NP-10-0010
June 24, 2010

Subject: Exelon Nuclear Texas Holdings, LLC
Victoria County Station
Early Site Permit Application
Environmental Report Revisions to Incorporate Additional Supporting
Information
Docket No. 52-042

ENCLOSURE 1

MARKUP PAGES OF VICTORIA COUNTY STATION ESPA

Figure 5.2-5 Schematic of Estuarine Ecosystem (SAC 2009)

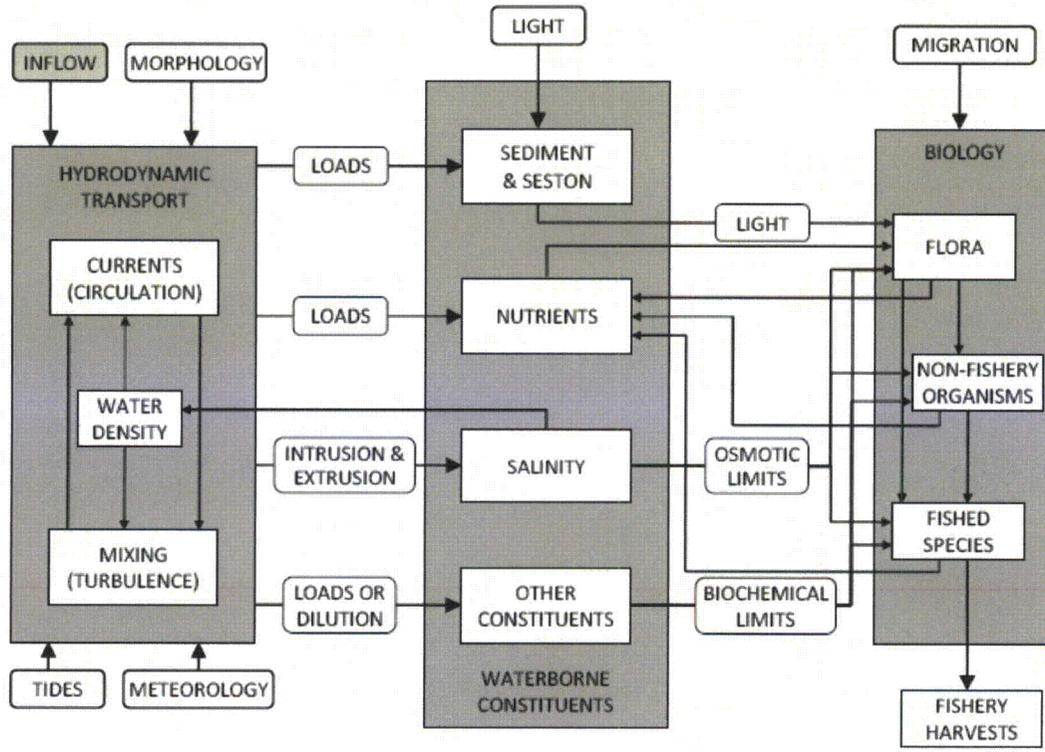
In its guidance towards establishing relationships between freshwater inflows and estuarine health, the Science Advisory Committee (SAC, established through Senate Bill 3 of the 77th Texas Legislature) provided a brief summary discussion on estuarine ecosystems and their major physio-chemical and biological variables. Figure 5.2-5 is a highly simplified diagram prepared by the SAC to represent causal relations among such estuarine processes. Despite the simplifications made in such a depiction, the diagram demonstrates that the estuarine ecosystem is highly dynamic and complex, being comprised of many variables and their interactions. The SAC has noted that it is not feasible to quantify each of the cause-and-effect relations diagrammed in Figure 5.2-5. Instead, the complexity of Figure 5.2-5 has been further distilled by the SAC to represent the most fundamental relations of inflow to the ecosystem in a form that may be feasible for determining inflow requirements. Figure 5.2-6 presents a conceptual schematic of the causal connection(s) between “inflow” and “biology.” (SAC 2009)
